MILLSTONE NUCLEAR POWER STATION, UNIT NO. 2

Amendment No. 91
License No. DPR-65

SAFETY EVALUATION BY THE OFFICE OF NUCLEAR REACTOR REGULATION

RELATED TO ISSUANCE OF AMENDMENT NO. 91 TO DPR-65

FIGURE 3.2-2 AXIAL SHAPE INDEX vs Fraction of Allowable Power Level per Specification 4.2.1.2c

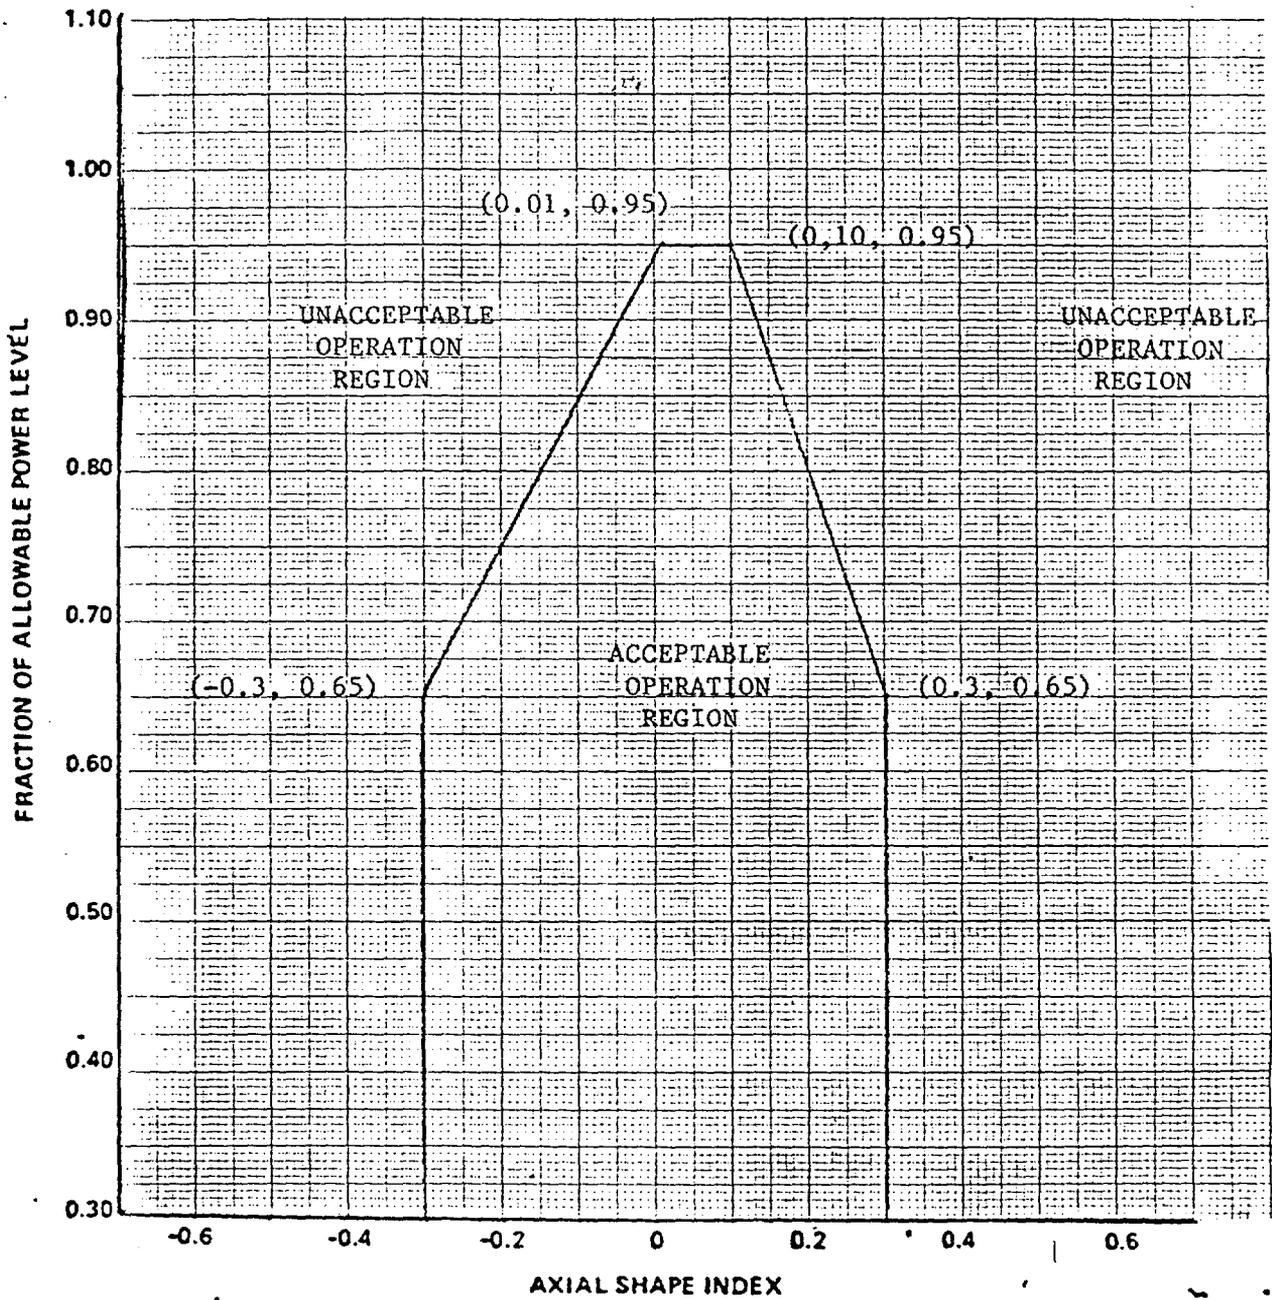
These changes modify the Technical Specifications concerning the total planar peaking factor limits. These changes cover the power levels between 92.5% and 100% limits. The curve has also been extended to include operation to 65% power. The curve of Axial Shape Index vs. Fraction of Allowable Power Level has also been revised to accommodate the peaking factor change.

The proposed revision of the total planar peaking factor F_{xy}^T curve is only of concern when the excore detectors are used to monitor linear heat rate. The licensee has proposed to conservatively offset the 4.3% increase in F_{xy}^T at full power with a 5.0% decrease in the axial shape index limits. The revised limits require that reactor power will be reduced to 95% of allowable rated power when the incore detectors are inoperable. An additional 2% correction is made to remove an unneeded general tilt allowance.

FIGURE 3.2-3 Total Radial Peaking Factor Versus Allowable Fraction of RATED THERMAL POWER

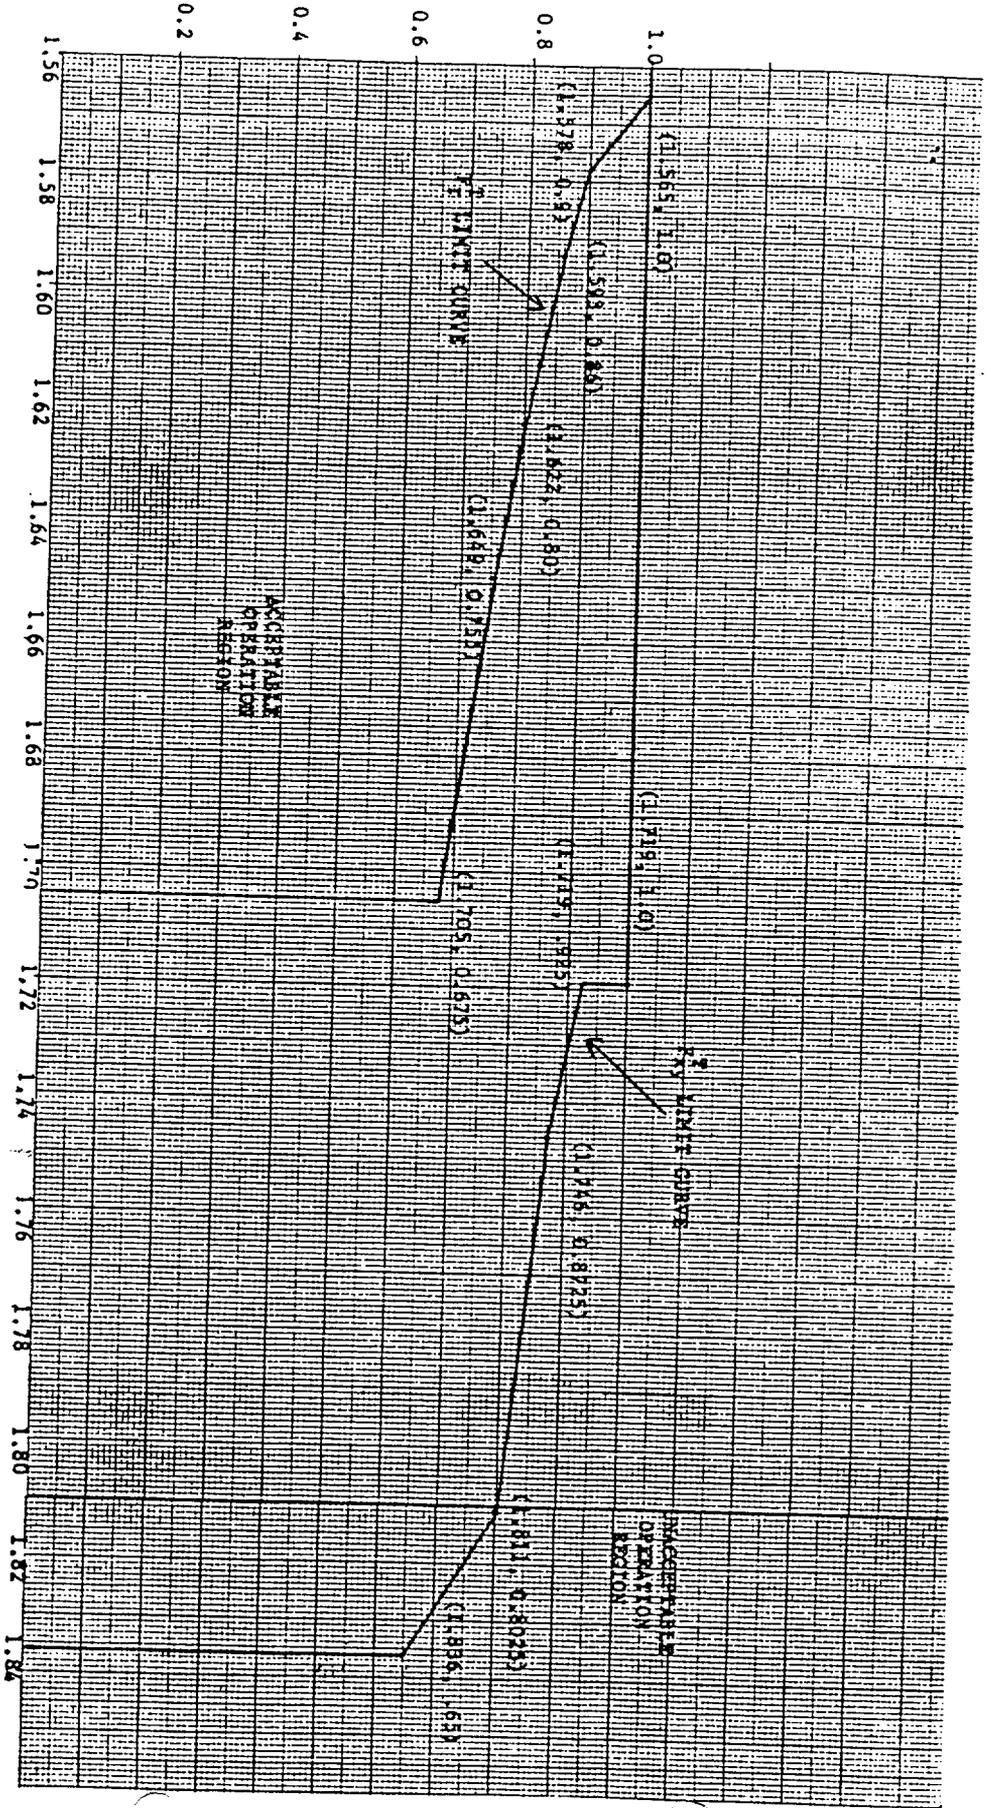
- A. Revised total planar peaking factor F_{xy}^T curve - This change affects pages 3/4 2-6 and 3/4 2-8. The allowable total planar peaking factor is increased by 6.3% in the range 0.925 to 1.000 of allowable fraction of rated power. The previous curve has been extended to 0.650 of rated power based on the Cycle 6 reload and safety analyses. The curve has also been corrected by 2% for the unneeded tilt allowance.
- B. New Axial Shape Index Tent - This change to page 3/4 2-4 involves a truncation of the current axial shape index tent at 95% power. This 5% reduction offsets the changes to the total planar peaking factor. Reactor operation above 95% of rated power is not acceptable if the incore detector system is inoperable.

With $F_{xy}^T > 1.719$, within 6 hours either:

- a. Reduce THERMAL POWER to bring the combination of THERMAL POWER and F_{xy}^T to within the limits of Figure 3.2-3 and withdraw the full length CEAs to or beyond the Long Term Steady State Insertion Limit of Specification 3.1.3.6; or
- b. Be in at least HOT STANDBY.
